Request for Quotation

RFQ NUMBER
 DEP13009

HUNT COAL U-5071-86
ADDENDUM #1

CHANGES TO SCOPE OF WORK AND BID SCHEDULE

OFFICE OF SPECIAL RECLAMATION	
SLUDGE DRYING CELL #3	
SCALE:	DRAWN BY:
DATE:	PROJECT NO:

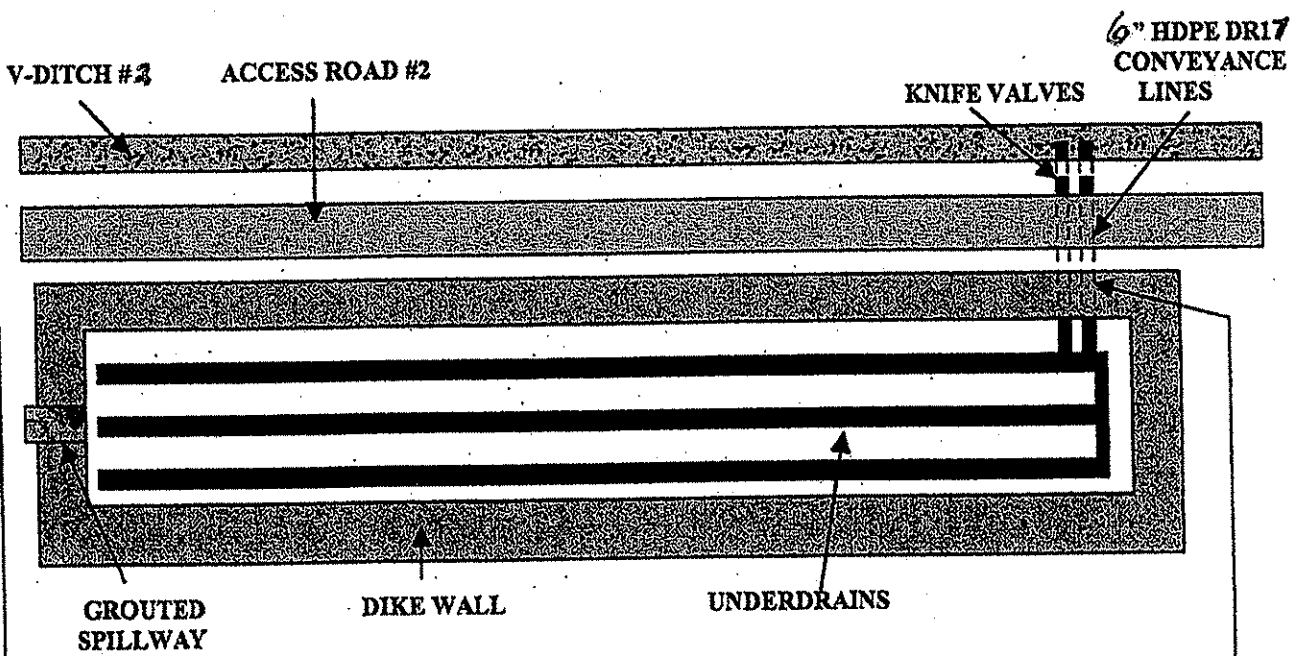
- 20) On the typical HEADWALL #2 AND #3, on page 76, change... "60" CMP PIPE"... to read ... "60" ADS PIPE." (A new typical is attached.)
- 21) On the typical SLUDGE DRYING CELL #3, page 81, change... "12" HDPE DR11 CONVEYANCE LINES"... to read... "6" HDPE DR17 CONVEYANCE LINES." Also change... "V-ditch #1"... to read... "V-ditch #2." (A new typical is attached.)

SPECIAL RECLAMATION	
POND #1	
CONCRETE ACCESS PAD	
SCALE: Not To Scale	DRAWN BY:
DATE:	PROJECT NO.:

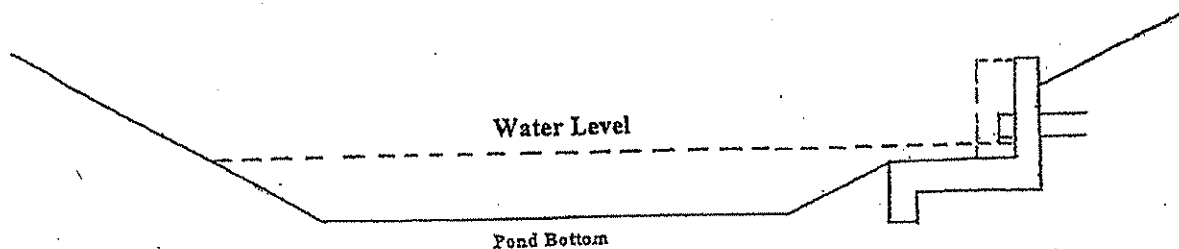
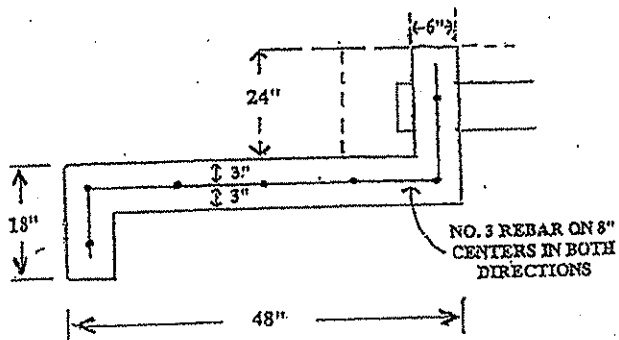
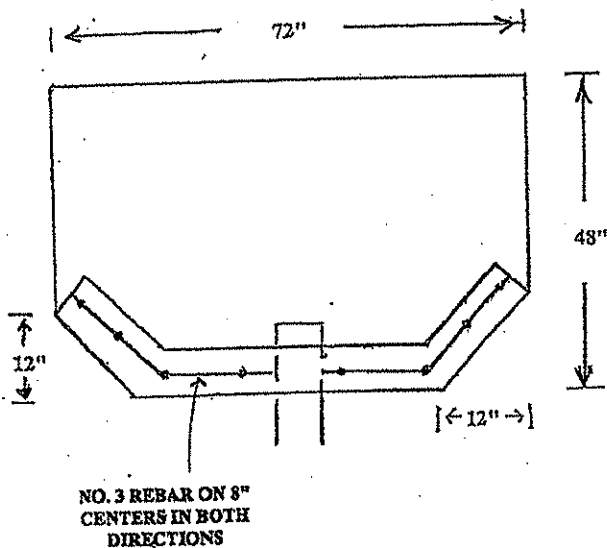
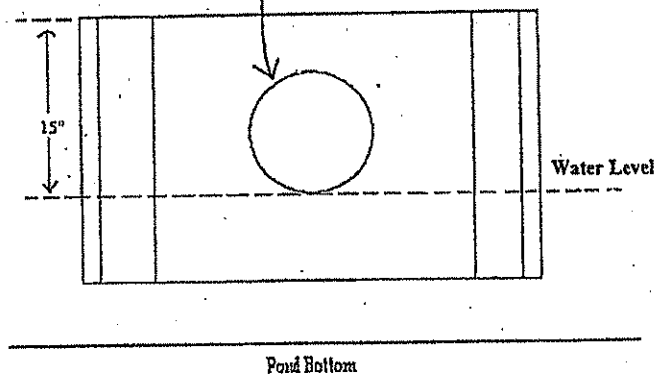
- 22) On the typical POND #1 CONCRETE ACCESS PAD, page 83, change... "12" HDPE DR11 PIPE"... to read ... "8" HDPE DR17 PIPE." (A new typical is attached.)

OFFICE OF SPECIAL RECLAMATION	
DECANT PIPE/ANCHOR PAD	
SCALE:	DRAWN BY:
DATE:	PROJECT NO:

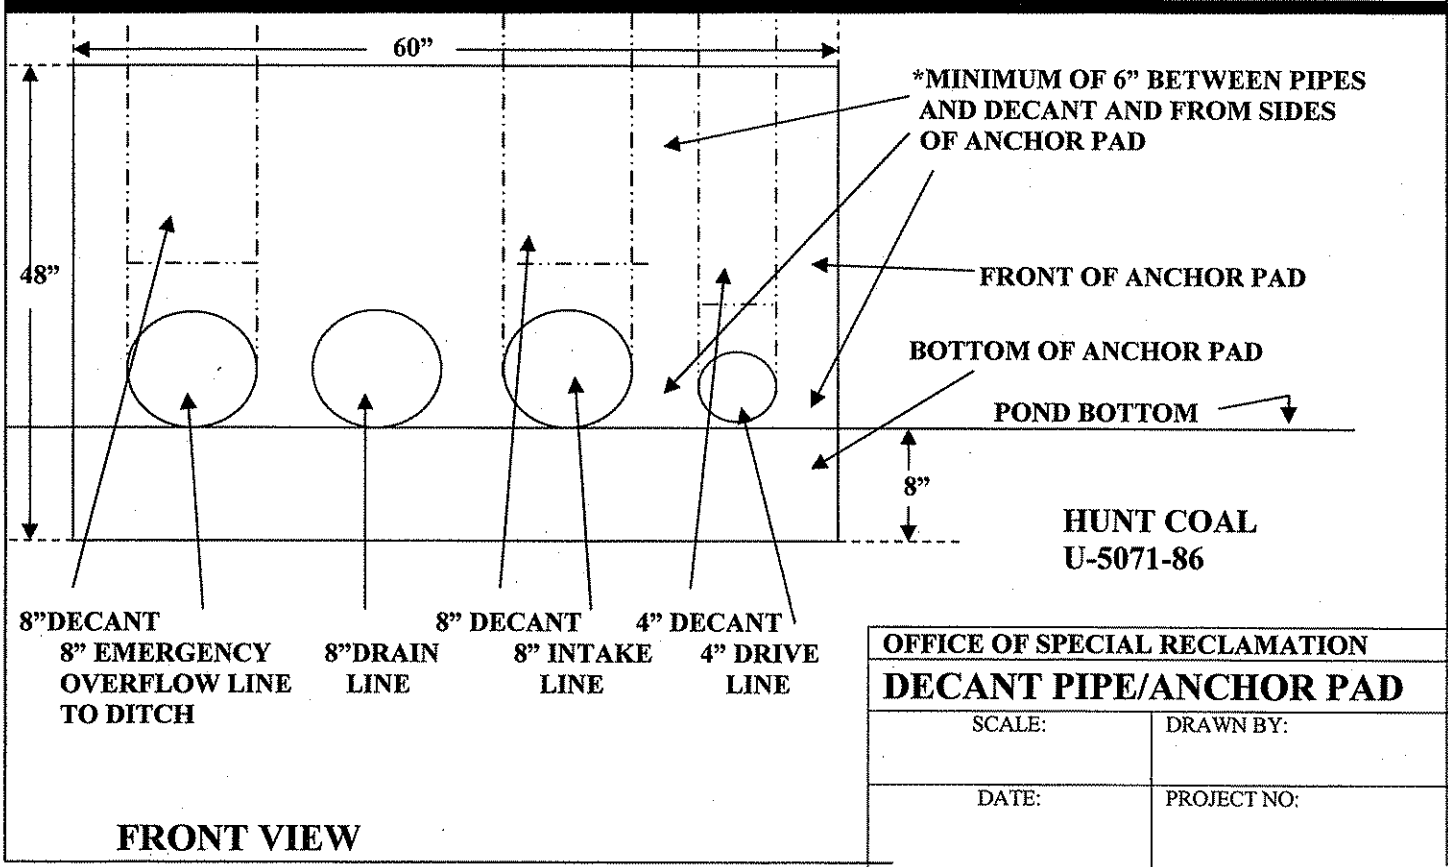
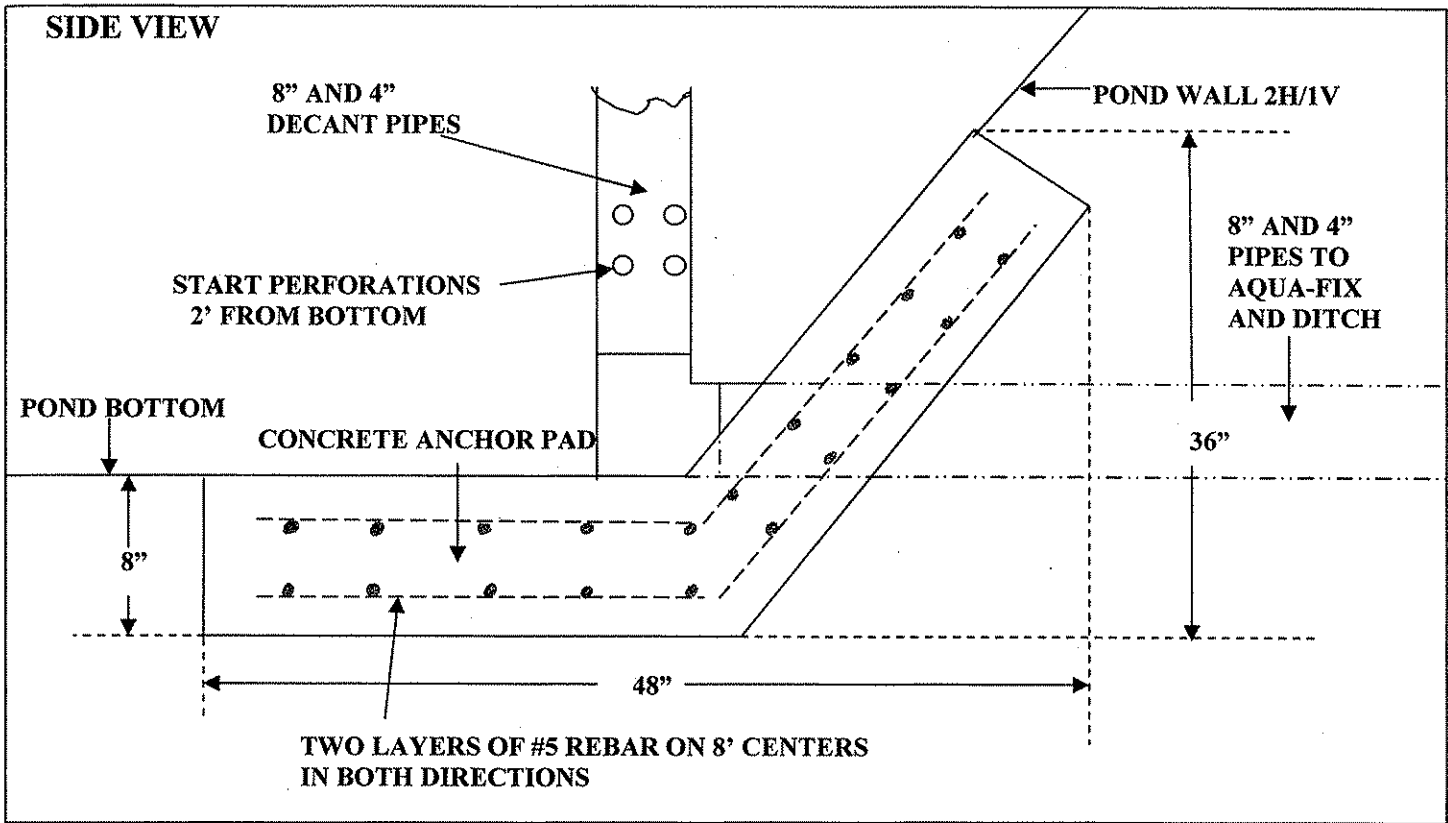
- 23) On page 84, typical DECANT PIPE ANCHOR PAD is being replaced with a new typical
- 24) On the typical PONDS 2 &3 CONCRETE ACCESS PAD, page 91, change... "12" HDPE DR11 PIPE"... to read ... "8" HDPE DR17 PIPE." (A new typical is attached.)

OFFICE OF SPECIAL RECLAMATION	
ACCESS ROAD/ VALLEY FILL	
SCALE:	DRAWN BY:
DATE:	PROJECT NO:

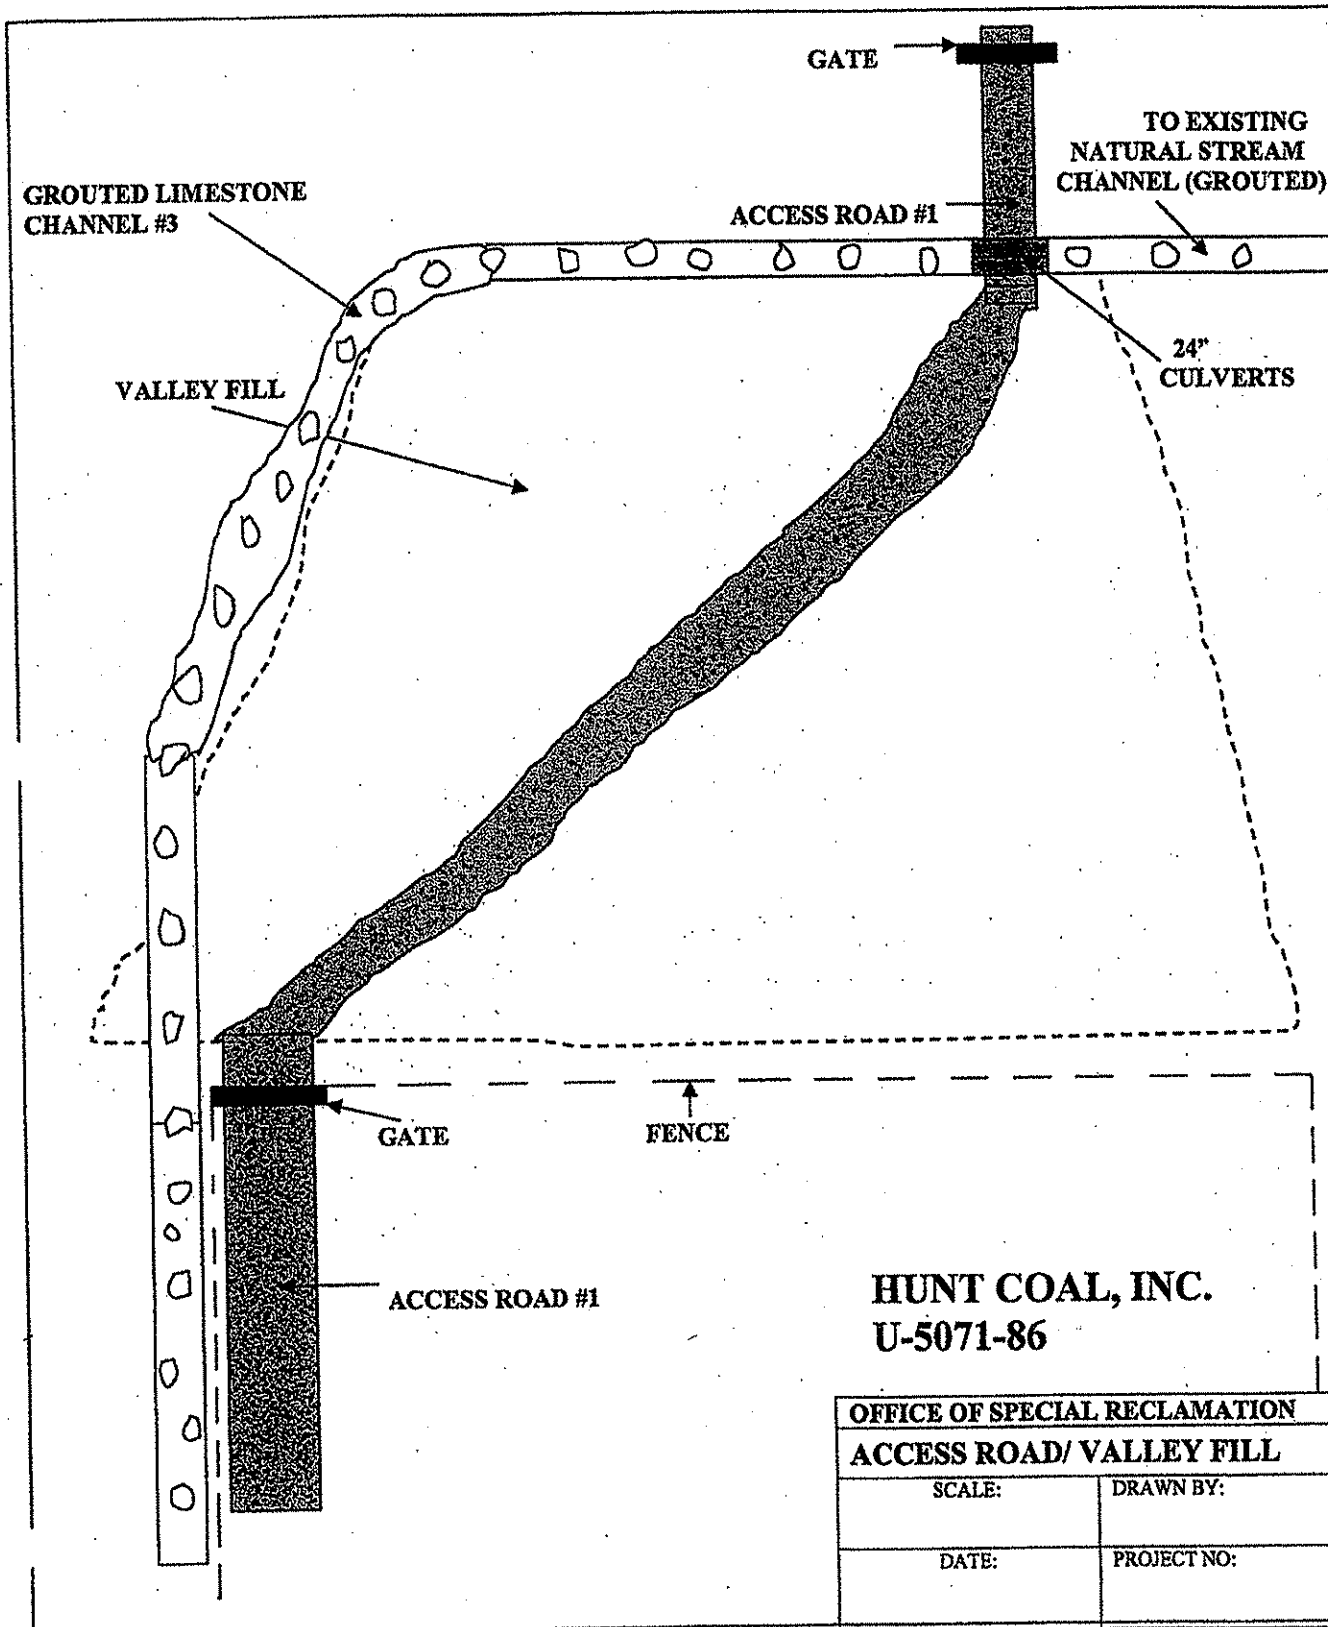
- 25) On the typical ACCESS ROAD/VALLEY FILL, page 96, change... "24" CMP CULVERTS"... to read... "24 INCH CULVERTS." (A new typical is attached.)
- 26) On the typical EXISTING ACCESS ROAD #3, page 97, change "EXISTING ROAD DITCH" to read "V-ditch #2." Also change note "*V-Ditch #1 and Access Road will continue to sediment ponds" to read "*V-ditch #2 and access road will continue to sediment ponds." (A new typical is attached.)

OFFICE OF SPECIAL RECLAMATION FENCING AQUA-FIX/STILLING BASIN	
SCALE:	DRAWN BY:
DATE:	PROJECT NO:

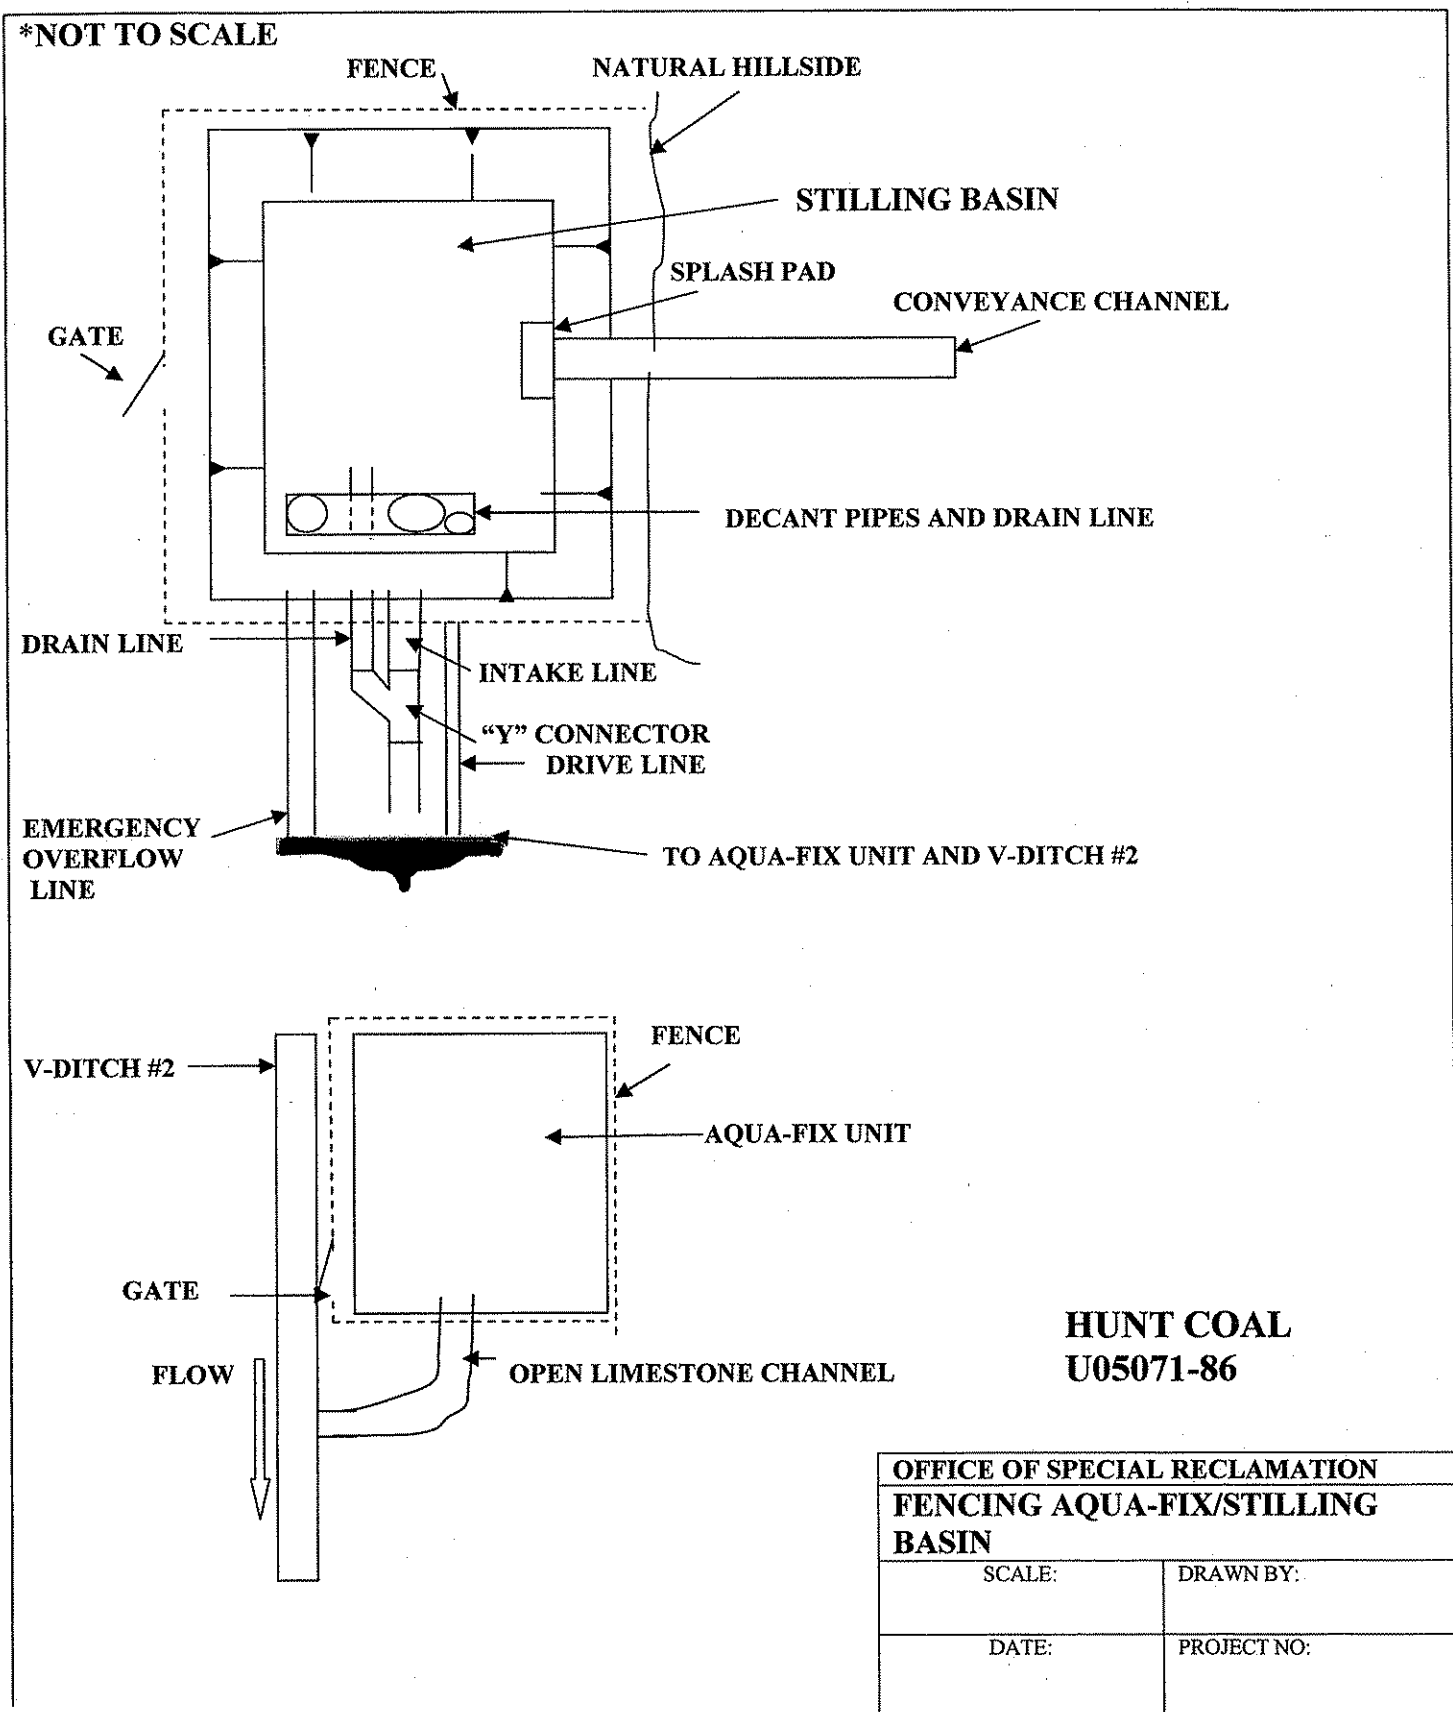
- 27) A new typical for TREATMENT UNIT FENCE, page 100, will replace the one in the package, and will be called FENCING AQUA-FIX/STILLING BASIN.
- 28) A new typical, on page 106, RESTRUCTURED STREAM CHANNEL, has been added. If needed, the stream channel above the valley fill can be restructured to a V-ditch configuration according to attached specifications. The ditch can be lined with the sandstone that is present in the stream channel.
